**RE: MODIFICATION REQUEST
SALT ASH SAND QUARRY PROJECT – MODIFICATION 4 (MP 07_0094
MOD 4)**

On behalf of Macka's Sand and Soil Supplies, I am writing to object to the proposed Modification 4 for the Salt Ash Sand Quarry Project. We reject the Redisand 'Modification to Redisand Salt Ash Sand Project' Environmental Assessment (the Redisand EA) based on two key points –

Janet Parade / Nelson Bay Road Intersection

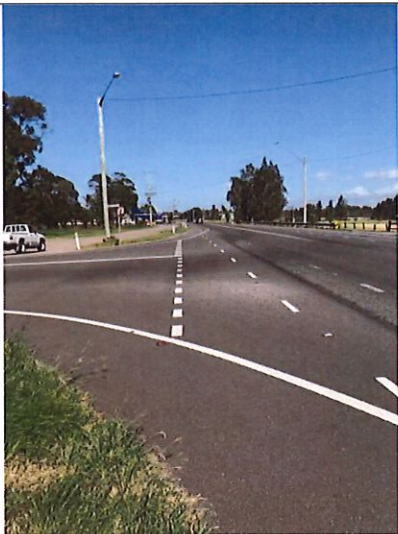
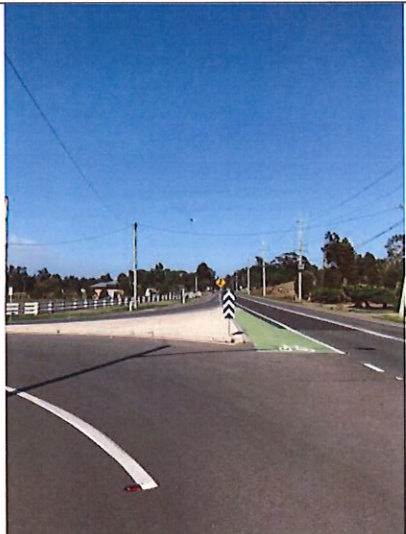
The currently approved intersection at Janet Parade and Nelson Bay Road does not provide an acceleration lane for haul truck movements exiting the site and turning left onto Nelson Bay Road, nor does it provide for an adequate deceleration lane for traffic approaching and entering the site to turn right onto Janet Parade. A small widening of the road has been completed as part of a previous modification, which allows for cars to pass haul trucks waiting to turn right onto Janet Parade.

A review of publicly available information on historical traffic incidents at the Janet Parade and Nelson Bay Road intersection has identified that four significant traffic incidents have occurred at the intersection since June 2015 (<http://www.snarl.com.au/incidents/suburb/nsw/salt+ash?p=5>). As a result, Macka's Sand sees no reason as to why the Janet Parade / Nelson Bay Road intersection should not be upgraded to allow for the safe movement of heavy vehicles at the intersection.
